THIS PLAN IS INTENDED TO SERVE AS AN ADDENDUM TO THE PREVIOUSLY APPROVED PLANS REFERENCED. THE PURPOSE OF THIS PLAN IS TO MODIFY THE APPROVED PLAN TO ALLOW FOR BETTER ACCESS FOR LARGE VEHICLES BY SOFTENING CURVES IN THE DRIVEWAY, AND TO LOWER THE FINISHED FLOOR ELEVATION OF THE OF THE PROPOSED BUILDING BY 1.5 FEET. ALL INFORMATION CONTAINED ON THE PREVIOUSLY APPROVED PLANS IS STILL APPLICABLE UNLESS SPECIFICALLY CALLED OUT ON THIS PLAN.

SITE PLAN REVISIONS
 PREPARED FOR
S&S WALL SYSTEMS
 40 LOWER BUTCHER ROAD
 ELLINGTON CT

Project: CES 19-79
 Date: SEP 23, 2019
 Scale: 1" = 30'
 Sheet: 1 OF 1

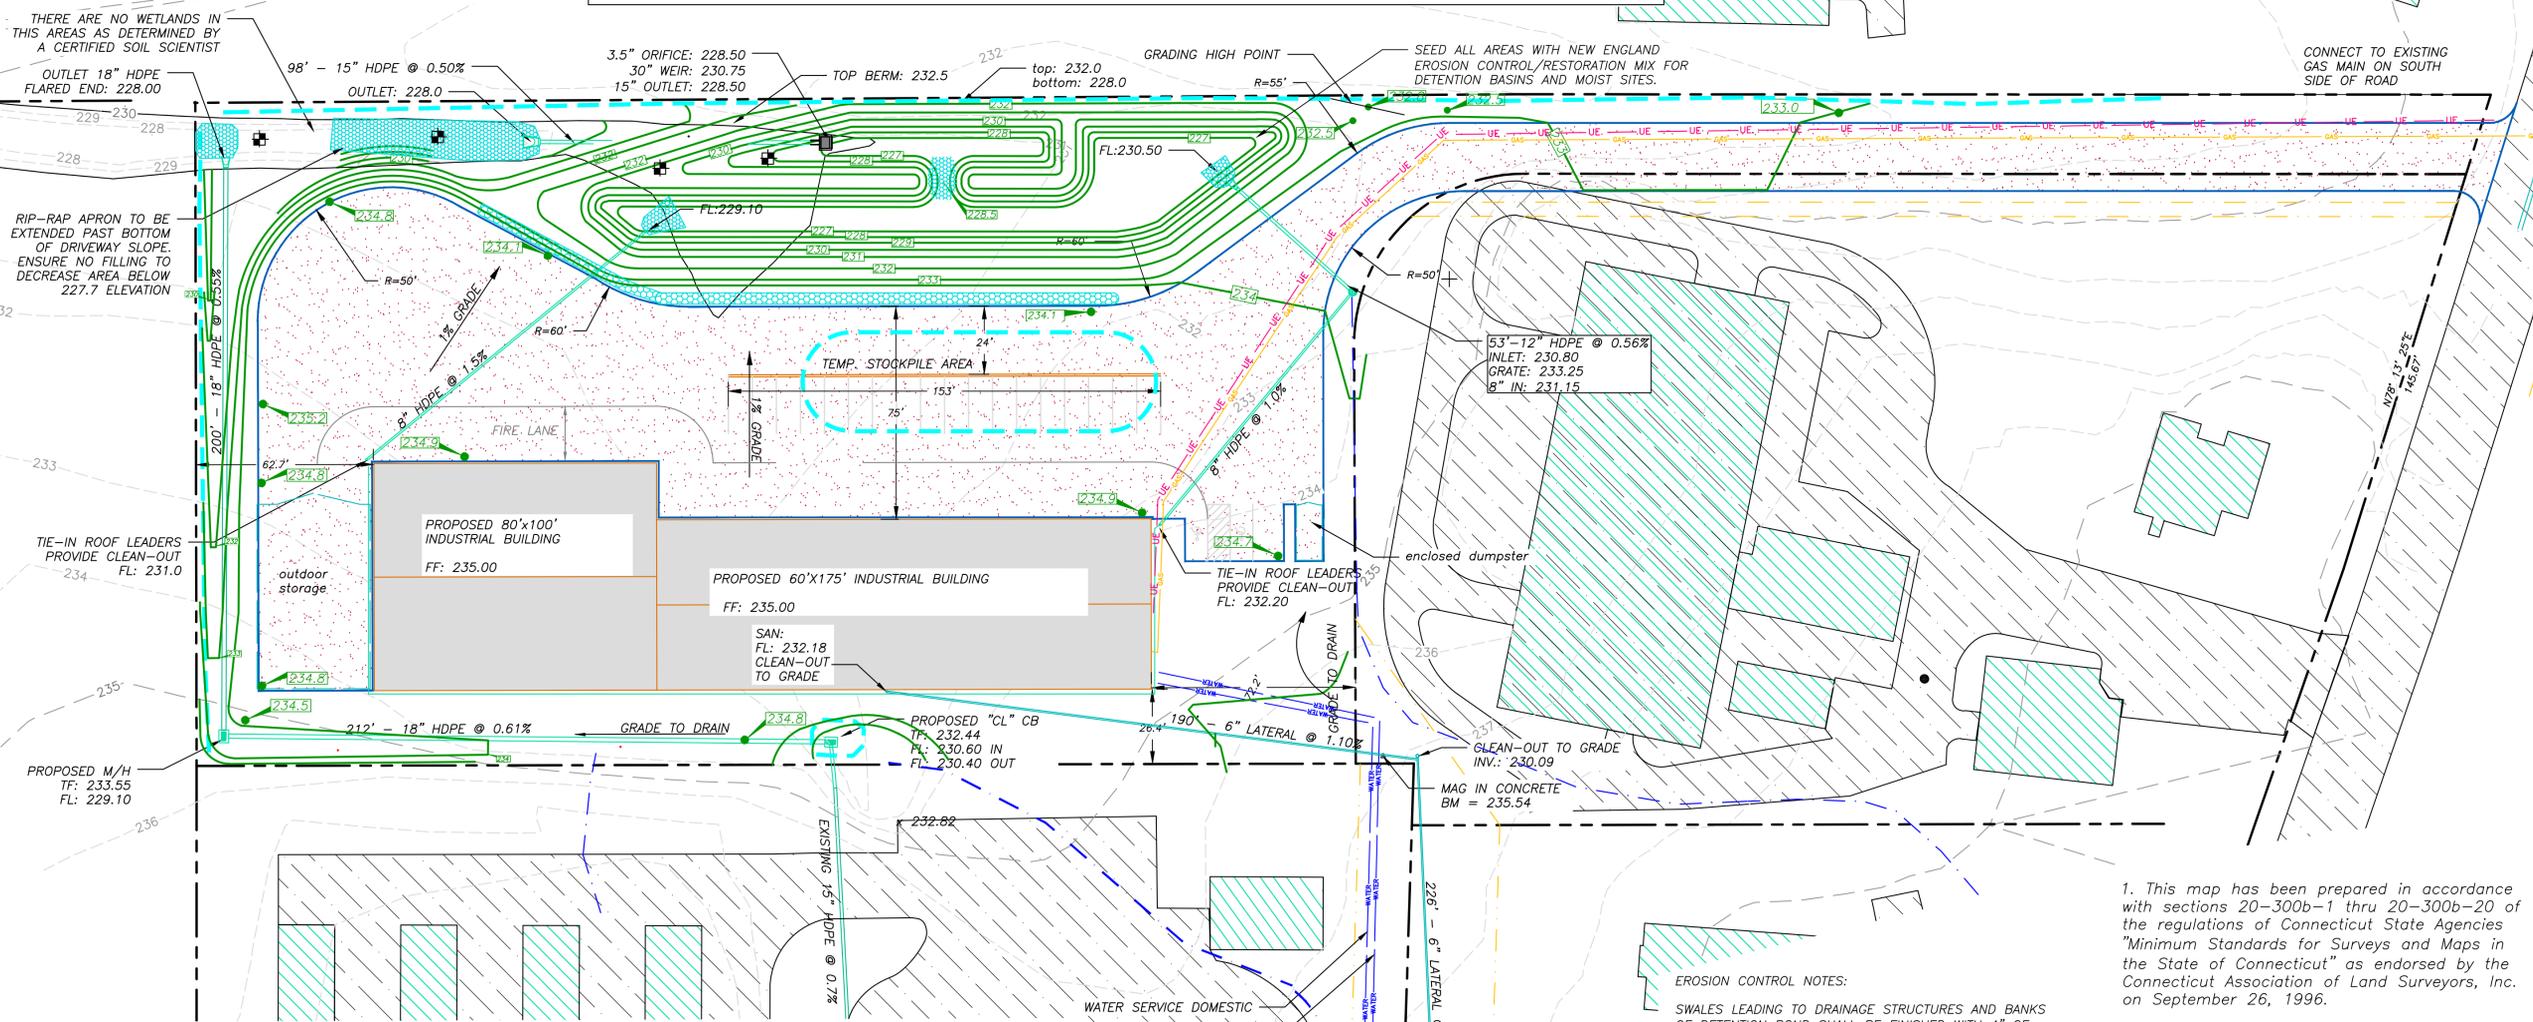
1. LOWER THE FINISHED FLOOR ELEVATION OF THE PROPOSED BUILDING.
2. RECONFIGURE (SLIGHTLY) THE DRIVEWAY AND PARKING AREAS. NOTE THAT LOCATION AND GRADES OF ENTRANCE DRIVE ARE NOT ALTERED FROM APPROVED PLAN.
3. CORRECT THE PROPOSED DISTANCES TO THE PROPERTY LINES (NORTH).
4. RESIZE THE PROPOSED NEW CULVERTS ON THE WEST AND NORTH SIDE OF THE BUILDING.
5. ELIMINATE CONCRETE CURBING AND CATCH BASINS, AND
6. RECONFIGURE THE DETENTION BASIN.
